SERVICE BULLETIN

OIL — TUBE ASSY, FRONT BEARING COMPARTMENT OIL VENT — INTRODUCTION OF A
NEW TUBE ASSY WITH A VENT LINE RESTRICTOR FOR REDUCED GROUND IDLE

V2500 Series 79-0106

V2500-ENG-79-0106

REPLACEMENT OF TUBE ASSY
FIGURE 1

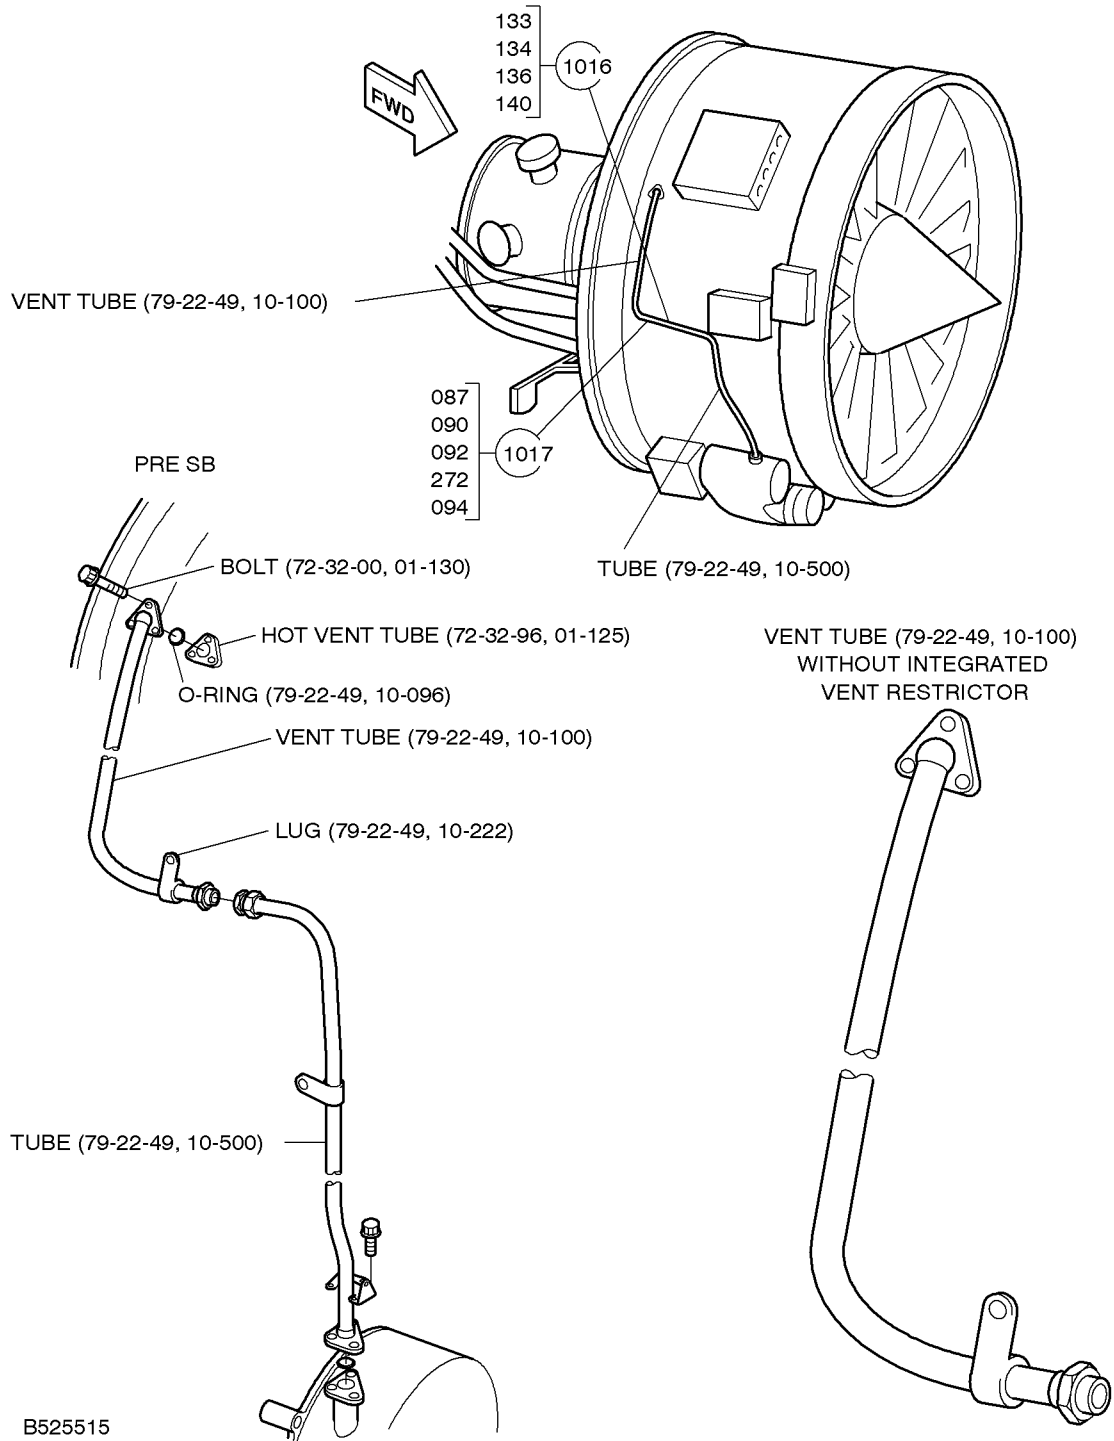
1. Open the fan cowl doors (Refer to Reference 5, Aircraft Maintenance Manual (AMM), Chapter/Section 71-13-00).
2. Remove Vent Tube (79-22-49, 10-100), refer to Figure 1.

- A. Remove the bolt, washer, clip nut, spacer and the clips attached to Brazed Lug (79-22-49, 10-222) clip position 1017.
 - B. Remove the bolt, washer, clip nut and clip at clip position 1016.

- C. Disconnect the Tube (79-22-49, 10-100)
 - (1) Remove the lockwire which safeties the tube nut of the Oil Tube (79-22-49, 10-500).
 - (2) Disconnect the Vent Tube (79-22-49, 10-100) with IAE 1R18003 (wrench).

- (3) Remove the three Bolts (72-32-00, 01-130) which attach Vent Tube (79-22-49, 10-100) to the Hot Vent Tube (72-32-96, 01-125).
 - (4) Remove and discard the Sealing Ring (79-22-49, 10-096) from the Vent Tube (79-22-49, 10-100).

- (5) Remove the Vent Tube (79-22-49, 10-100).
 - (6) Retain bolts if serviceable, unserviceable bolts will need to be replaced prior to reinstallation.

REPLACEMENT OF TUBE ASSY
FIGURE 2

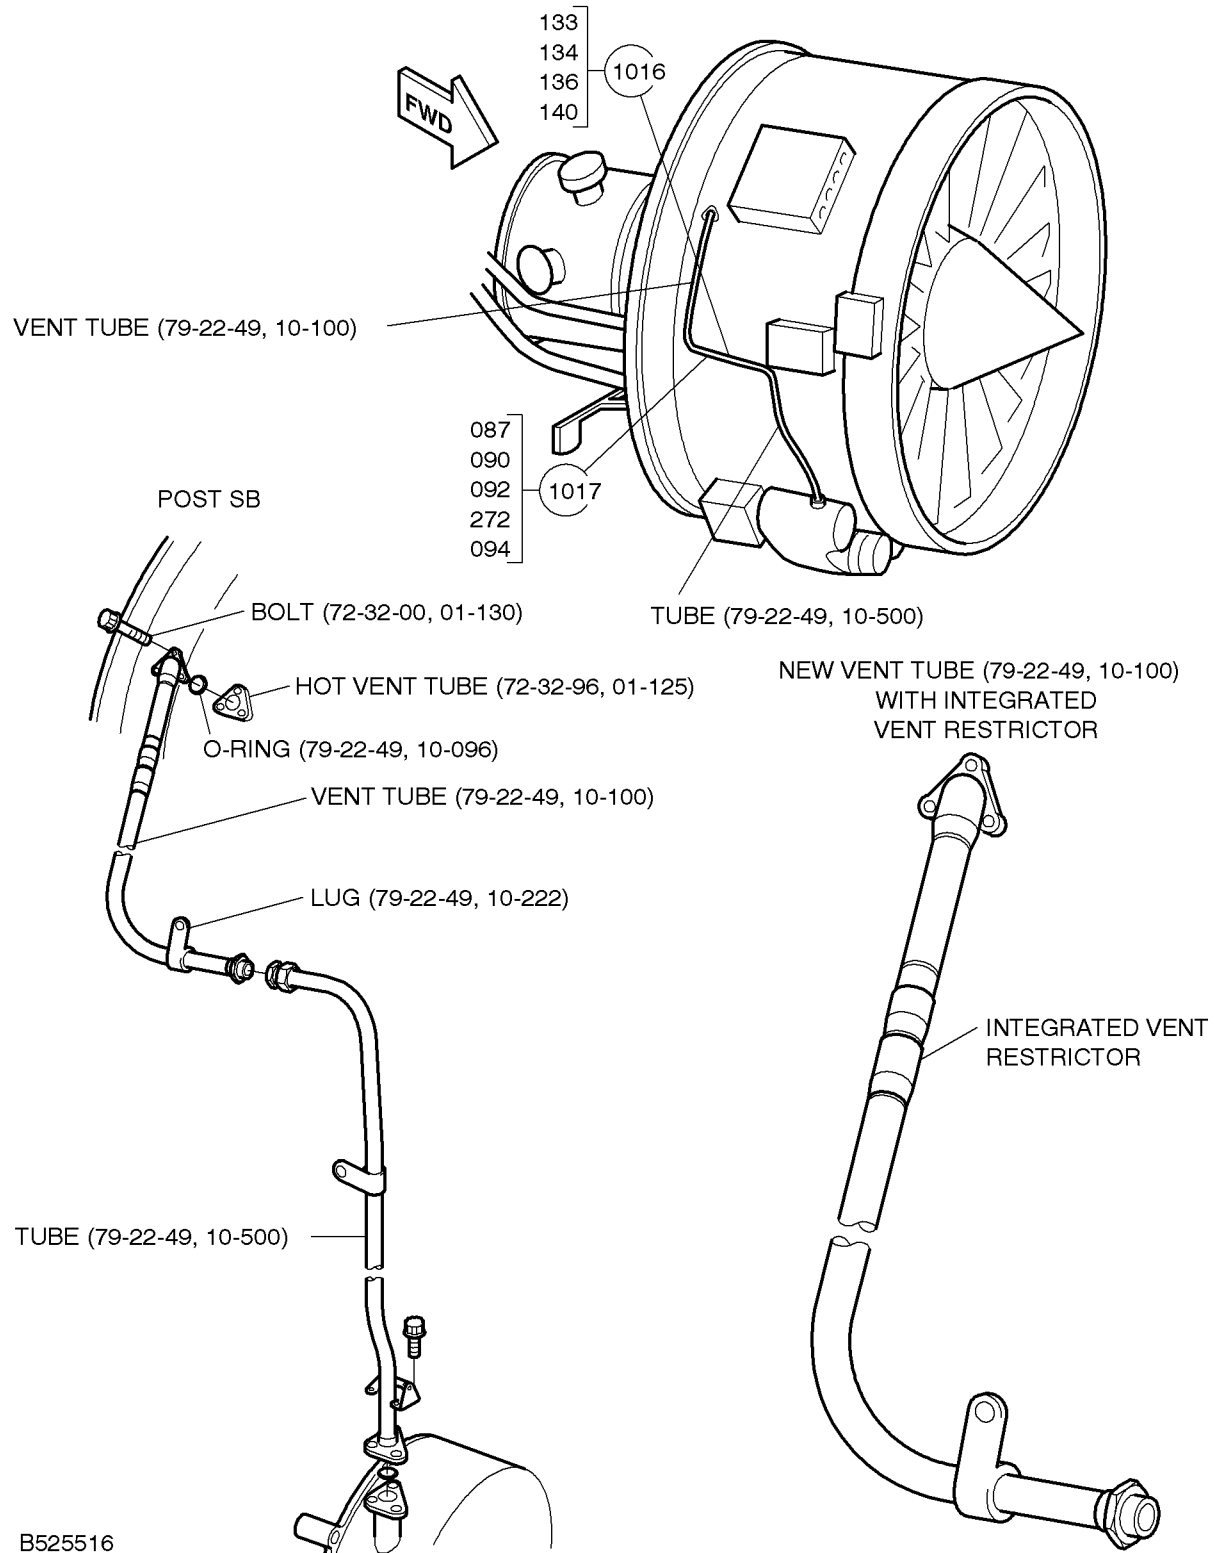
3. Install Vent Tube, PN 6B1584 (79-22-49, 10-100). Refer to Figure 2.
 - A. Lubricate the bolts removed in step 2 with CoMat 10-077 approved engine oil.

- B. Lubricate a new Sealing Ring (79-22-49, 10-096) with CoMat 10-077 approved engine oil.
 - C. Install the Sealing Ring (79-22-49, 10-096) on the Vent Tube (79-22-49, 10-100).

- D. Install the Vent Tube (79-22-49, 10-100) to the Hot Vent Tube (72-32-96, 01-125) with the three Bolts (72-32-00, 01-130). Tighten the bolts lightly.

- E. Install the clip around Vent Tube (79-22-49, 10-100) at clip position 1016 and install them to the bracket with the bolts, washer and clip nut. Tighten the bolts lightly.

- F. Torque the three Bolts (72-32-00, 01-130) to 85 to 105 lbf in (10 to 12 Nm).
 - G. Torque the Bolt (79-22-49, 10-133) at the clip position 1016 to 36 to 45 lbf in (4 to 5 Nm).

- H. Connect the Vent Tube (79-22-49, 10-100) to the Oil Tube (79-22-49, 10-500).
 - I. Torque the nut to 566 to 611 lbf in (64 to 69 Nm) with the IAE 1R18003 (wrench). Safety the tube nut with CoMat 02-126 lockwire.

- J. At clip position 1017 attach the Clip (71-51-41,02-090) around the harness and second Clip (73-22-49, 07-272) around the Vent Tube (73-22-49, 07-100) to the Brazed Lug (79-22-49, 10-222) with the bolt, washer, spacer, and nut.
- K. Torque Bolt (71-51-41, 02-087) to 36 to 45 lbf in (4 to 5 Nm).
- 4. Make sure that working area is clean and free from foreign objects.
- 5. Close the fan cowl doors (Refer to Reference 5, Aircraft Maintenance Manual (AMM), Chapter 71-13-00).
- 6. Perform Idle Leak Check Test #3 (Refer to Reference 5, Aircraft Maintenance Manual (AMM), Chapter 71-00-00-710-012).
- 7. Recording Instructions
 - A. A record of accomplishment is required.
